UNITED STATES PATENT AND TRADEMARK OFFICE

APPLICATION NO.	FILING DATE	FIRST NAMED INVENTOR	ATTORNEY DOCKET NO.	CONFIRMATION NO.
09/934,930	08/22/2001	Jugo Mitomo	09792909-5153	8886

Office Action Summary

DETAILED ACTION

FIGS. 9A and 9B are perspective sectional views of the device showing the fourth embodiment of the present invention.

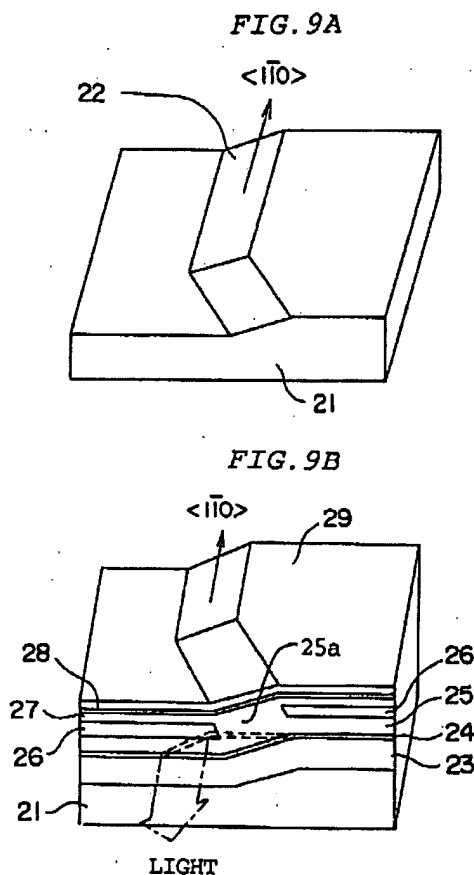
7. Claims 1-18, to the extent understood, are rejected under 35 U.S.C. 102(b) as being anticipated by Furuya (5,568,500). Furuya discloses the claimed invention. Note figures 9A and 9B comprising a substrate (21), a semiconductor stack (23-29), at least one step-like structure (22).
